Final Flood Planning Assessment

Campsie Town Centre

NW30274

Prepared for Canterbury-Bankstown Council

Figure 3-1 Campsie Town Centre Master Plan – Framework Map Showing the Proposed Future Town Layout

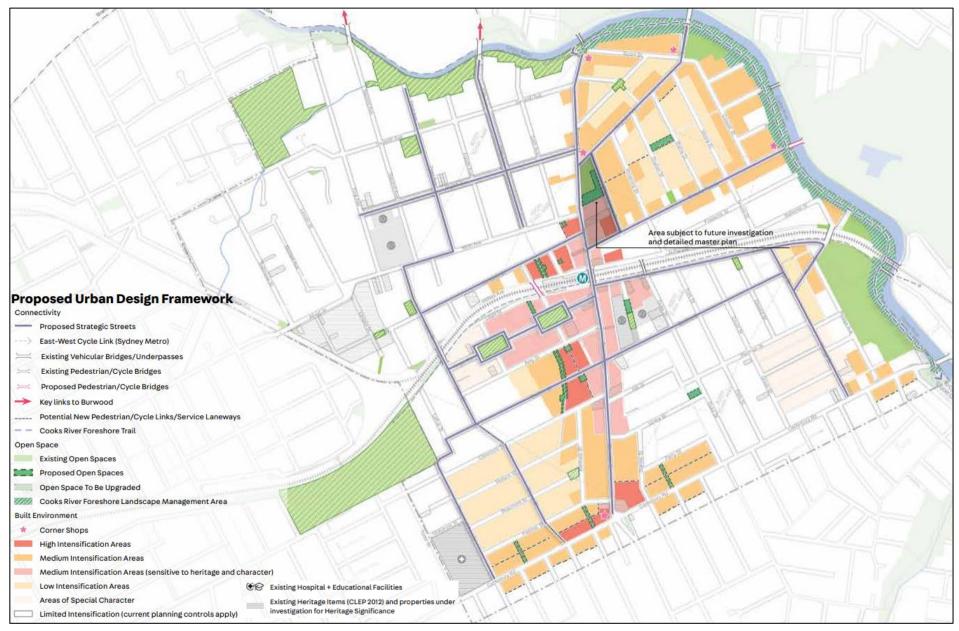
This is particularly relevant for the Master Plan as can be seen in **Figure 3-1**, a large portion of the study area is proposed for intensified development (the shaded areas in the figure). The proposed intensification is required to accommodate the additional residents in the Town Centre over the next 20 years.

No alterations to the Master Plan are recommended in response to this Policy provision, however it is recommended that this interpretation and conclusion be confirmed by Council in discussions with DPE.

Figure 4-1 Numbered Locations of Land Use Changes from Master Plan

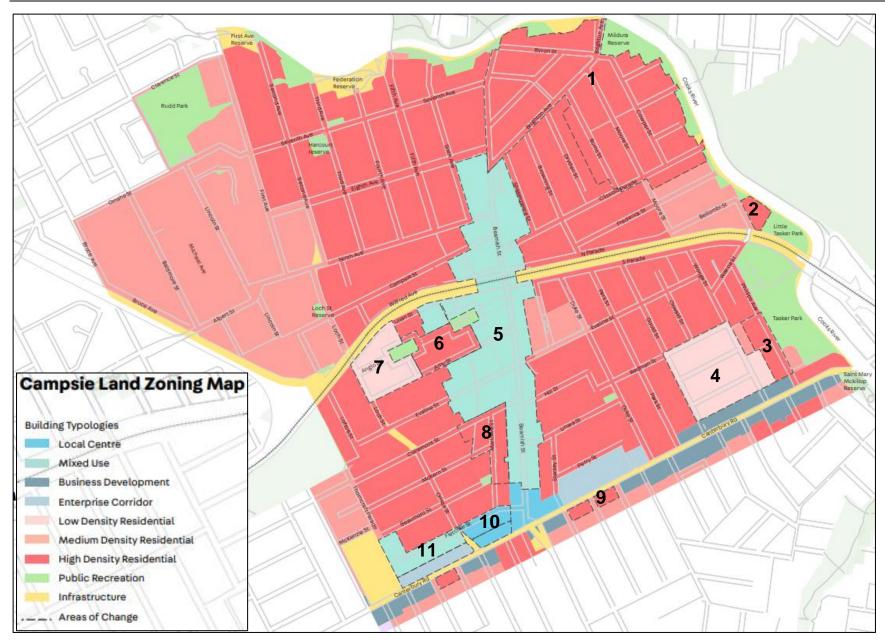
A summary of the land use change areas proposed in the Master Plan with location numbering is shown in **Figure 4-1**. The land use changes for the numbered areas, and whether or not they are flood affected and therefore not in accordance with this provision of the Policy is summarised in **Table 4-1**. All land use changes are not in the categories listed in the NSW Flood Prone Land 2021 package, therefore are eligible changes even if they are flood affected.

In most instances, the proposed intensification will be in the form of vertical development with maximum height and FSR increases to accommodate the growing population. As discussed in the previous section, for the proposed change of land use areas, most involve an intensification of land use as well (for example locations 1-4, 6-7 and 9 all involve change from medium to high density residential zones).

Regarding land use changes in the floodplain, it appears that the Master Plan meets these requirements as all proposed land use changes are eligible in the floodplain.

Figure 8. PMF H1-H6 Hazard and Proposed Zoning

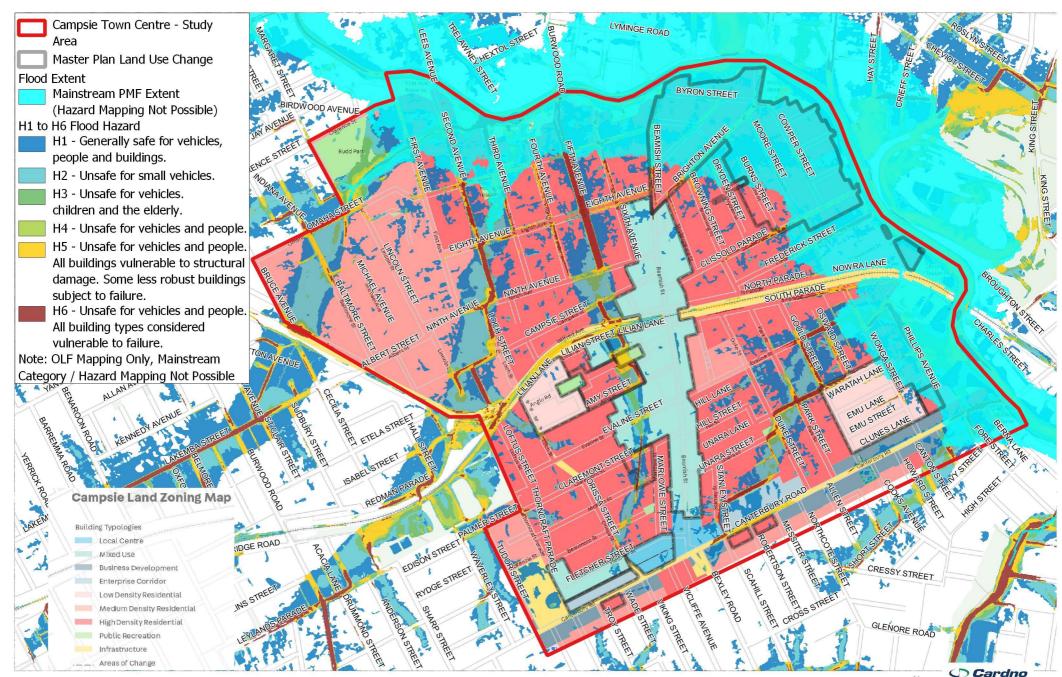
This discussion of flood emergency response focusses on the PMF. The PMF H1-H6 hazard category mapping overlaid the proposed land use zoning is shown in Figure 8 of **Appendix A**.

This high level review of flood emergency response considerations suggests that both horizontal flood evacuation and shelter-in-place (vertical evacuation) should be feasible for the majority of the development areas proposed under 2021 Master Plan. The flash flooding regime means that site-specific FERPs should be feasible without a need to increase the burden on emergency services or any regional evacuation routes. Therefore, the Master Plan is compatible with the flood emergency response guidance provided in the NSW Flood Prone Land 2021 package. This is a broadscale review of potential for the study area. The identification of appropriate flood emergency responses needs to be undertaken on a site-by-site basis and should be applied through Council's role as a consent authority.

Figure 9: Special Flood Considerations

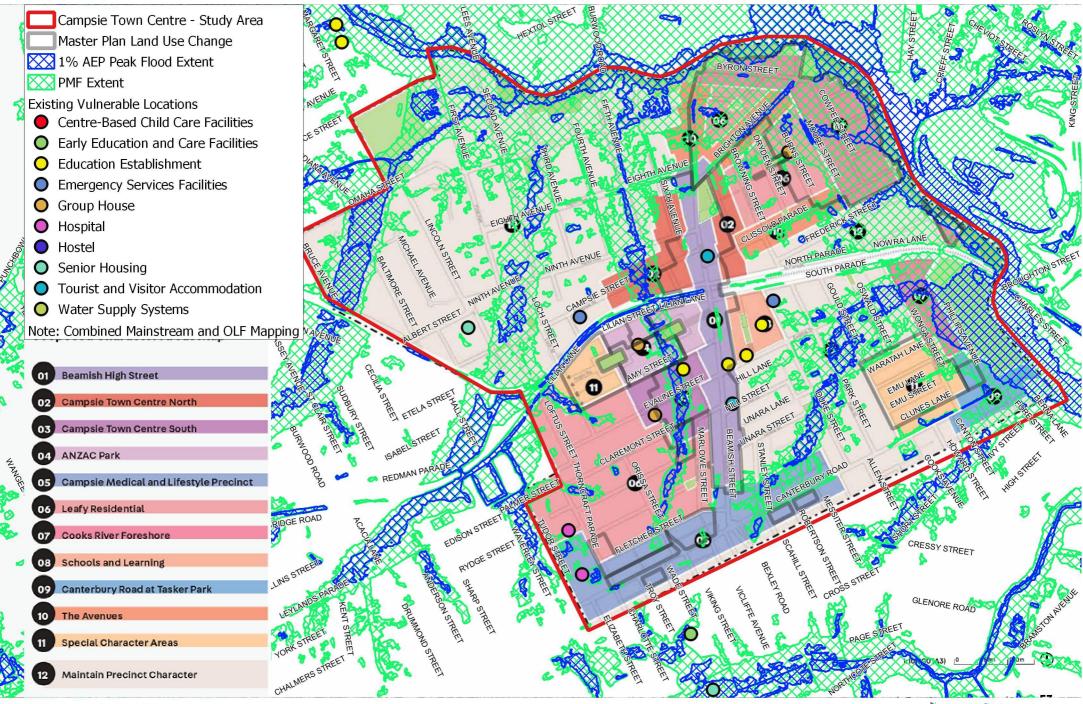
The existing vulnerable developments in the study area have been mapped and are compared to the 1% AEP and PMF flood extents in Figure 9 of **Appendix A**. With respect to proposed vulnerable developments, the character map from the Master Plan has been included in Figure 9. It identifies the "05 Campsie Medical and Lifestyle Precinct" that will likely contain the majority of future vulnerable developments.

As shown in Figure 9 of **Appendix A**, there are a number of existing vulnerable developments within the study area that are on the fringe of the floodplain or marginally affected by flooding. However, most existing vulnerable sites appear to be on land higher than the PMF level. The potential redevelopment of any flood affected vulnerable development sites in accordance with the Master Plan offers an opportunity to apply flood-related development controls to reduce the existing flood risk for these sensitive-use sites.

Within the Master Plan, the "05 Campsie Medical and Lifestyle Precinct" located near Canterbury Hospital and Canterbury Road to the south of the study area will likely contain the majority of future medical-related vulnerable developments. This area contains the existing Canterbury Hospital as well as associated medical clinics and facilities proposed to be developed around the hospital.

Figure 9 of **Appendix A** shows that this area experiences negligible inundation in both the 1% AEP flood and the PMF. This is a result of the precinct being located in the upper reaches of the study area. Consequently, the Master Plan has identified a suitable location for most vulnerable developments in the less flood affected portion of the study area. Though the entire "Campsie Medical and Lifestyle Precinct" is not completely flood free, the overland flow flooding in the area means that drainage upgrades and appropriate site design could feasibly reduce flood risk for these sites up to and including in the PMF.

Regarding existing flood affected vulnerable developments, the Master Plan offers an opportunity for redevelopment of any flood affected sites to potentially reduce the flood risk. Therefore the proposed zoning of the Master Plan is considered to be in accordance with the intent of the SFC and vulnerable development provisions of the NSW Flood Prone Land 2021.
